## Product Change Notice (PCN)

**PCN Number:** PCN-0460231R-01**To Our Customers:**

**Product(s) Affected:** TB009-508 series

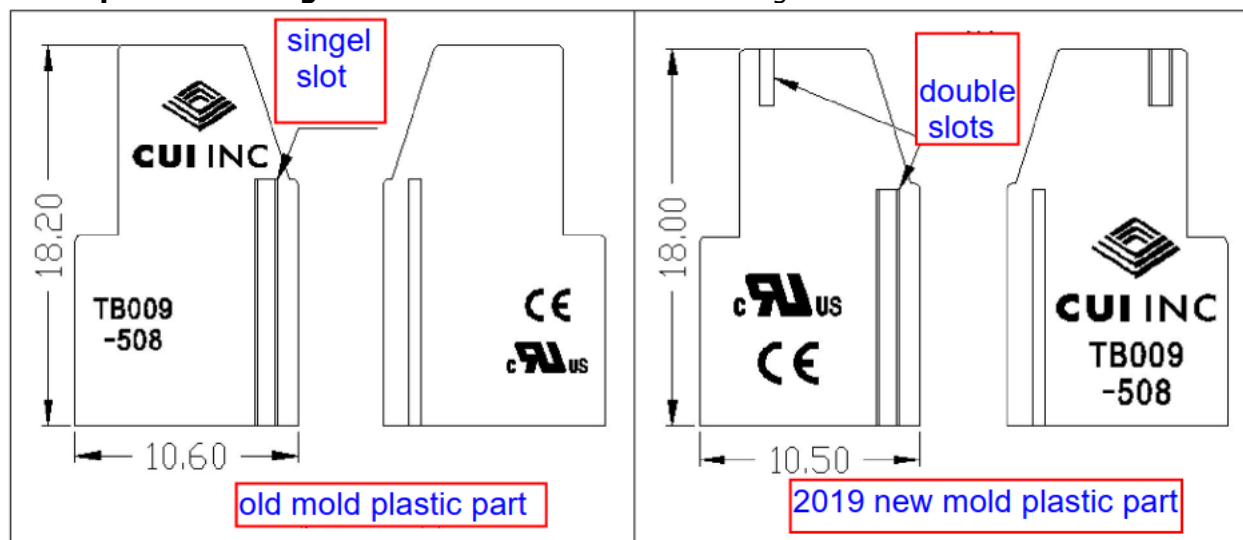
**Reason(s) for Change:** To promote the efficiency of automated assembly machine.

**Description of Change:** Additional slot for ease of configuration as shown below:

**Additional Information:** Products using the old mold cannot be connected to products using the new mold.
